TRANS/WP.1/2003/3/Rev.4 23 April 2004

Working Party on Road Traffic Safety

Proposals for amendments to the 1968 Vienna Convention on Road Signs and Signals

Note by the secretariat

Add the new symbols F, 14 and F, 15 below:

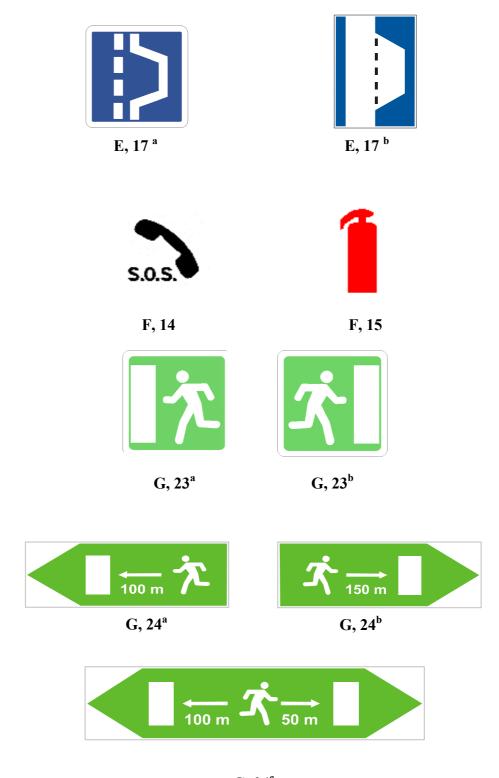
Sign E, 17 "EMERGENCY STOPPING PLACE" indicates a place which shall only be used by drivers for stopping or parking in case of emergency or danger. If this stopping place is equipped with an emergency telephone and/or an extinguisher, the sign shall bear the symbols F, 14 and/or F, 15 either in its lower part or on a rectangular panel placed below the sign. This sign has two models, E, 17^a and E, 17^b."

"F, 14 'EMERGENCY TELEPHONE'"

"F, 15 'EXTINGUISHER'"
